**BOARD OF COUNTY COMMISSIONERS
ESCAMBIA COUNTY, FLORIDA**

ADDENDUM NUMBER 2:

Re: Southwest Greenway Connector Trail - Specification Number PD 11-12.007

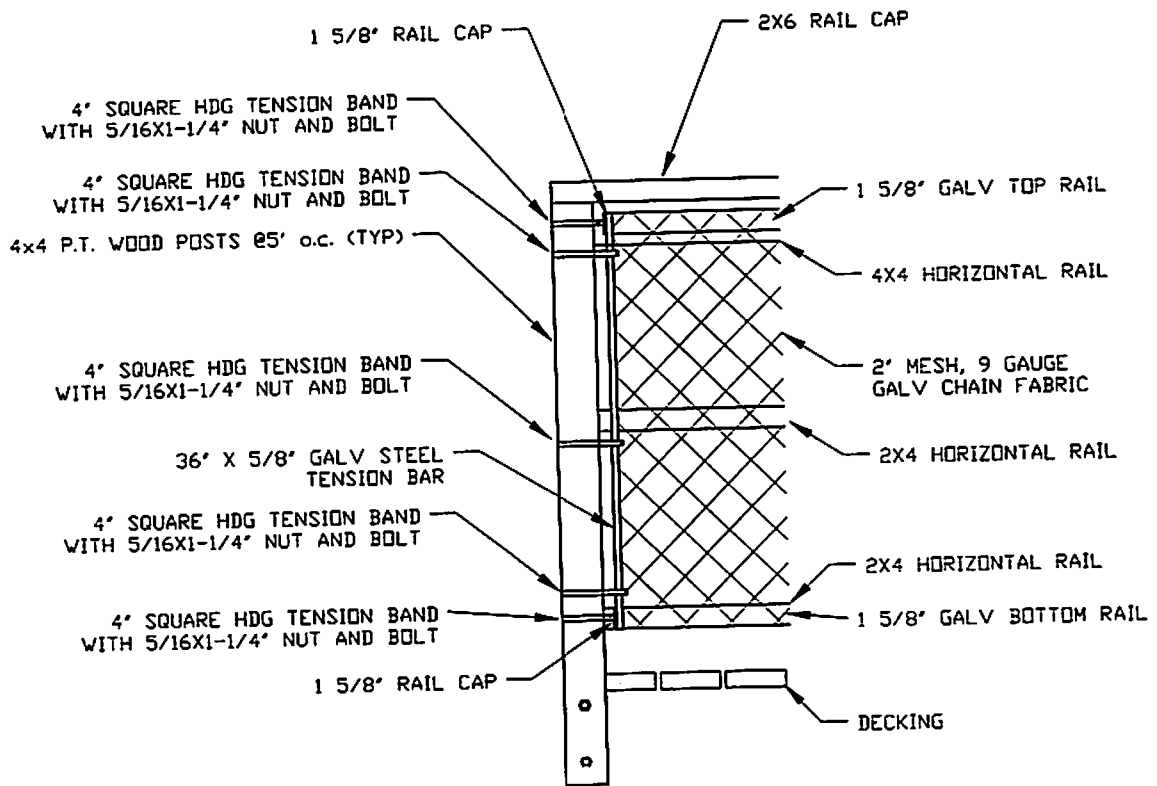
33. *"Girder end caps do you want this as shown"*

Construct as shown.

TERMINAL HOOKUP
CHAIN RAIL OPTION

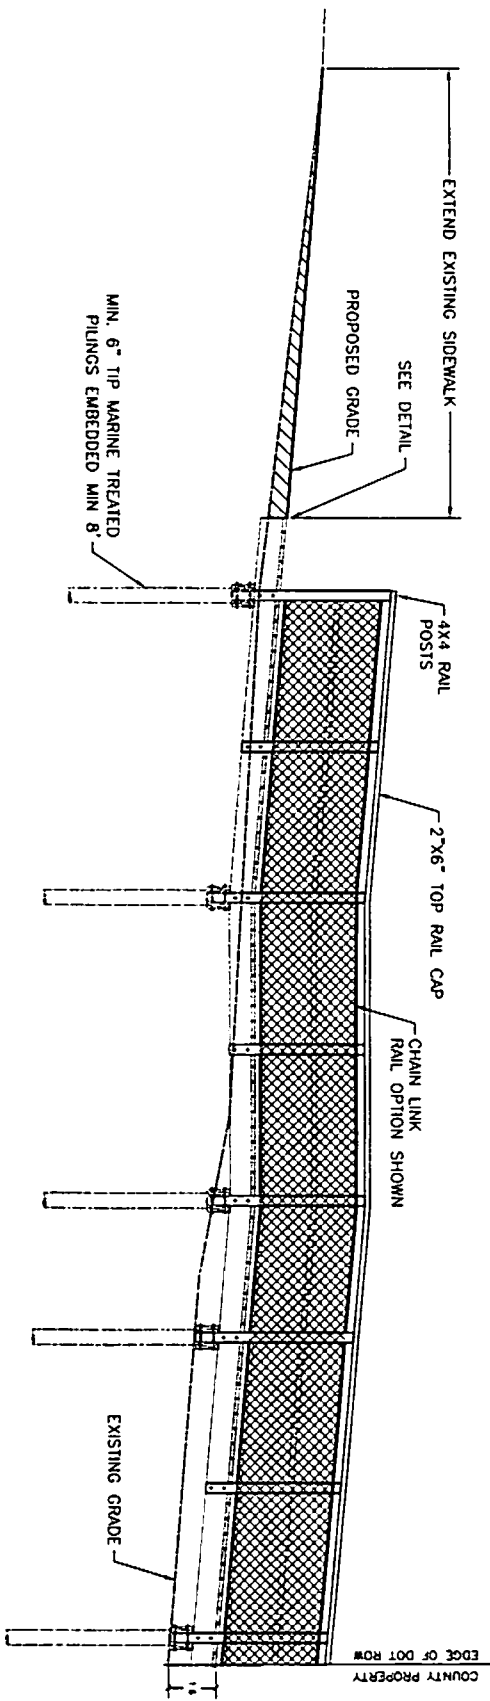
26. *"Please provide a clear detail of the chain link configuration. Are there vertical post? Is the chain link built in panels and screwed to the post? The profile on sheet 9 does not show the pipe rails to be continuous." ; Are the 1-1/2" pipe rails that chain link attaches to running horizontally at top and bottom and or vertically?"*

See attached detail. The chain link fabric is continuous. Fabric will be attached to the rail posts using 4 inch H.D.G. square tension bands. There will be a minimum of three tension bands per connection. Length of the fabric will dictate the number of connections. Pipe rails are continuous. They will be attached to the rail posts using 4 inch H.D.G. square tension bands and 1-5/8 inch aluminum rail cap. Each tension band will require a single 5/16 x 1-1/4 inch galvanized nut and bolt. A 36 inch x 5/8 inch steel galvanized tension bar should be used for each connection.

BOARDWALK PROFILE

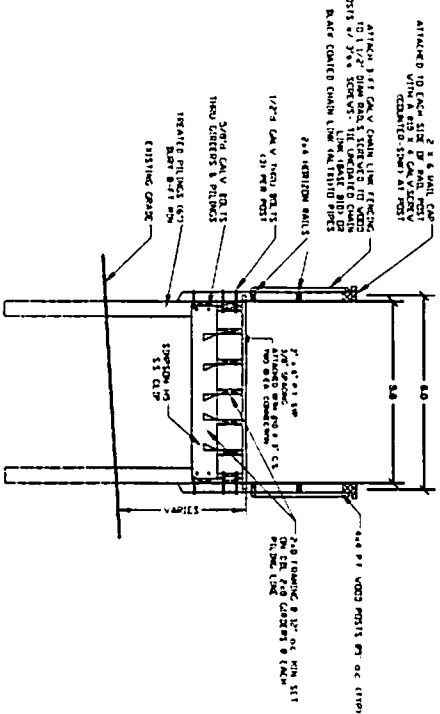
24. "Detail 2/Sheet 9 (Chain link) shows three horizontal rails (2x4 middle & bottom, 4x4 top rail) that are not shown in the profile drawing. Are these rails required?"; "On pg. 9 under the 2x6 top rail framing shows what seems to be a 4x4 there is additional 2x4 under this horizontal what do you want please"; "Alt 1 fasteners what do you require at. 2x4 horizontal railing"
The 4x4 located immediately under the 2x6 cap shall be located in between each 4x4 rail post. The 2x6 rail cap will be placed on top of the rail posts and horizontal 4x4 rail. The 4x4 horizontal rail shall be attached to the 4x4 rail post using 3x3 inch heavy gauge ell brackets with three holes each flange. Ell brackets shall be secured to the rail and post using 1-1/2 inch stainless steel screws. 2x4 horizontal rails shall be attached to the 4x4 rail post using 3x3 inch heavy gauge ell brackets with three holes each flange. Ell brackets shall be secured to the rail and post using 3/4 inch stainless steel screws.

BOARDWALK CROSS SECTION CHAIN LINK RAIL BASE & ALT#1

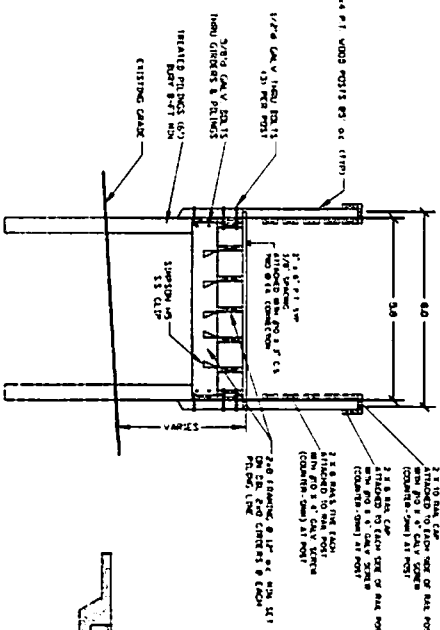
19. "Will 6'-0 (cut 2 from a 2x6x12'-0) long deck boards be acceptable? The drawings (2/2 on sht.9) show the deck boards running past the 6'-0 width dimension which would create an enormous amount of waste."; "Page 9 of the plans, boardwalk section, chain link rail - This detail shows the chain link rail on the outboard side of the boardwalk as opposed to wooden rail. If the rail stays outboard, this will require the use of 7 - 2 x6's in order to close the gap between the end of the joist and the rail or an additional waste of 2500 lineal feet of lumber."; "The rail detail with wood handrails is inboard of the deck area which allows us to use 6'0" material for decking. The detail using the chain link fence rail is outboard of the 6' deck area and will require a decked width of 6'7" in order not to have an opening at the bottom of the rail. We would need to use 7' long deck board and the total amount of cut off would be 2500 lineal feet of 2 x 6." Overall boardwalk width has been adjusted for both handrail options. See attached detail.

BOARDWALK CROSS SECTION WOODEN RAIL ALT#2

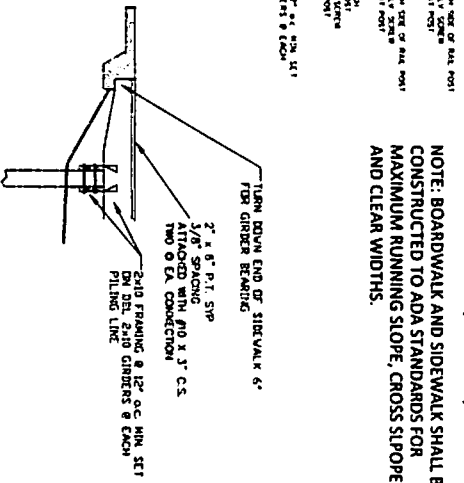
25. *"On alt two 2x6 hand rails do you want 4 as shown or 5 that's written"*
Five 2x6 rails are shown on the drawings. The fifth rail is located beneath the 2x6 rail cap.
